Refer to: LIGO-M030132-00-P

Subject: LIGO Change Control Board (CCB) Meeting Minutes - June 23, 2003

CR-030011—Seismic External Pre-Isolation (EPI) at LIGO Livingston Observatory

CR-030013-- Atomic Clock Timing System (Operations WBS 2.02.8.X and 2.03.8.X)

Figure 2.2 HEPI/BSC X-direction Isolation ASD (control on and off) at LASTI

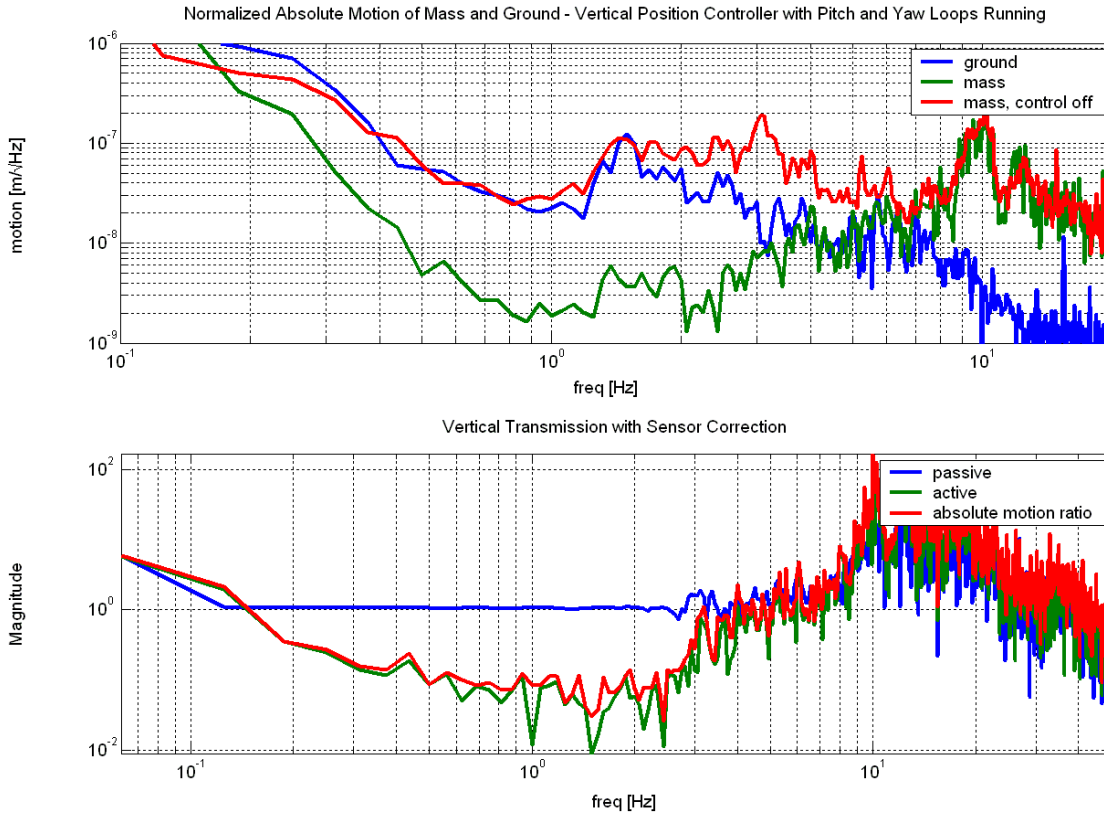
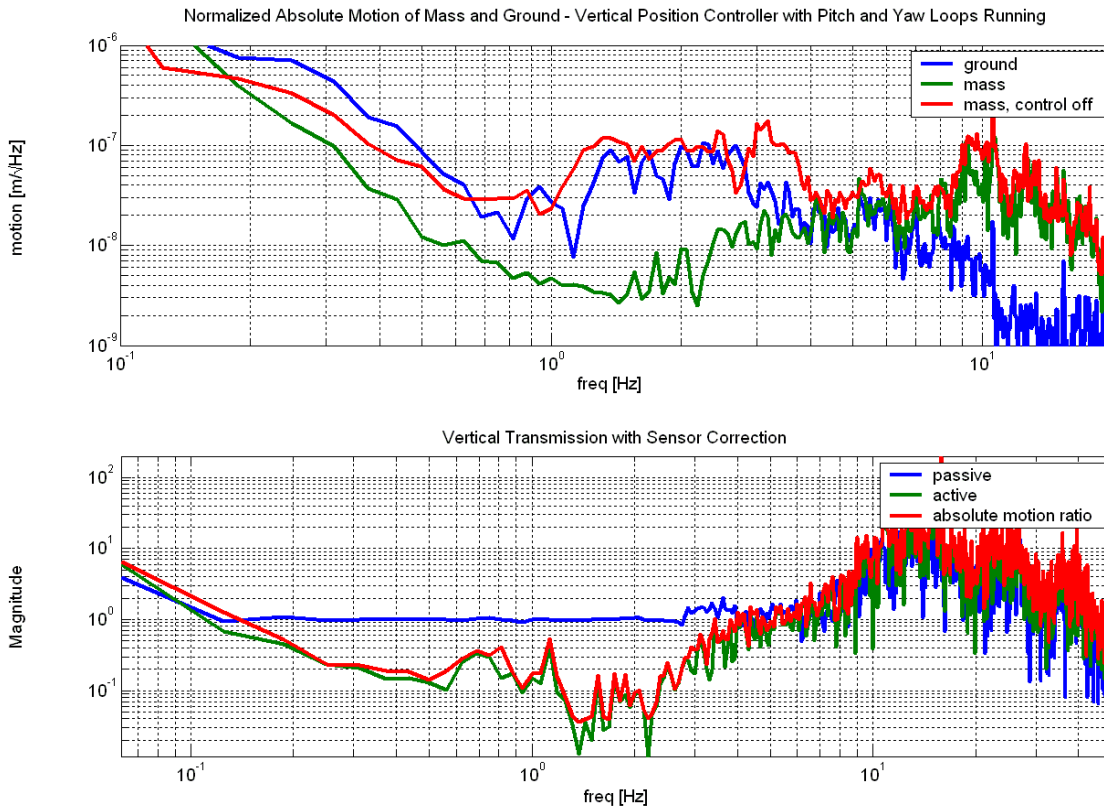
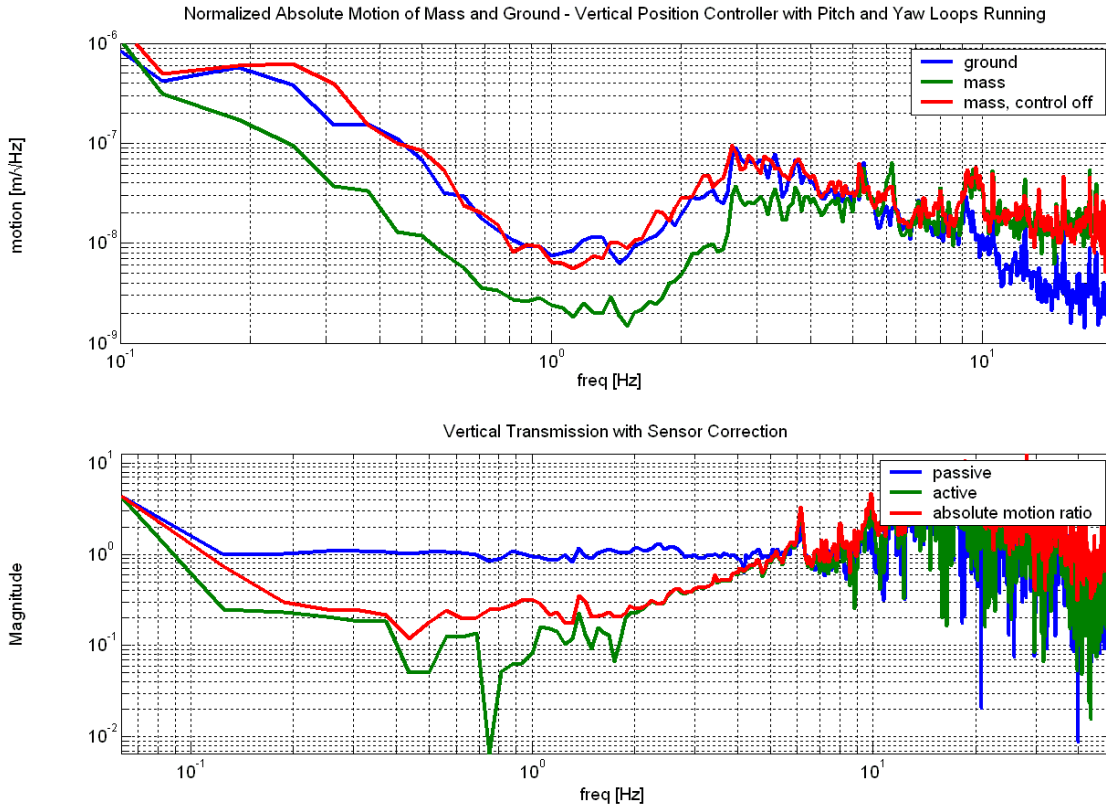
[Note: Should overlay requirement curve and crossbeam amplification on figures 2.2 through 2.4]

Figure 2.5: MEPI/HAM X-Direction Isolation Performance vs Requirements

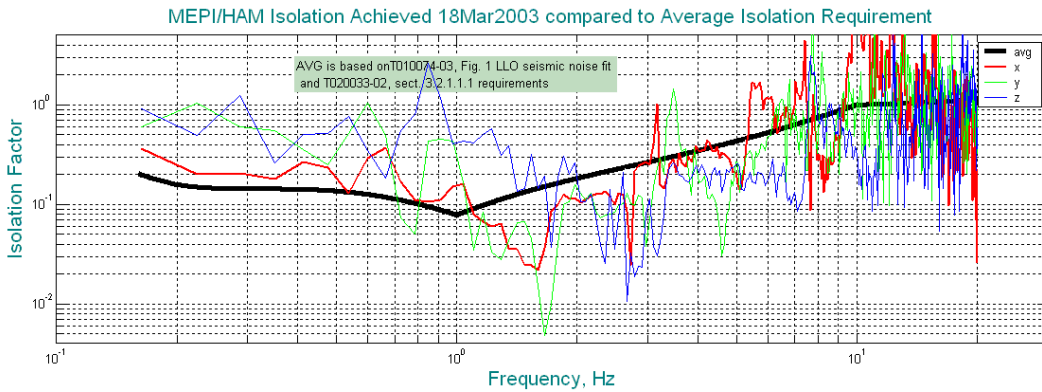
Note that it is expected that the performance of the MEPI/HAM system below 1 Hz is can be improved through more optimal filtering and setting of the sensor correction gain.

[Note: Should include MEPI/HAM ASD, not just attenuation. See better and more recent MEPI/HAM isolation performance plots in D. Ottaway, R. Mittleman, presentation for the 4/18 review]
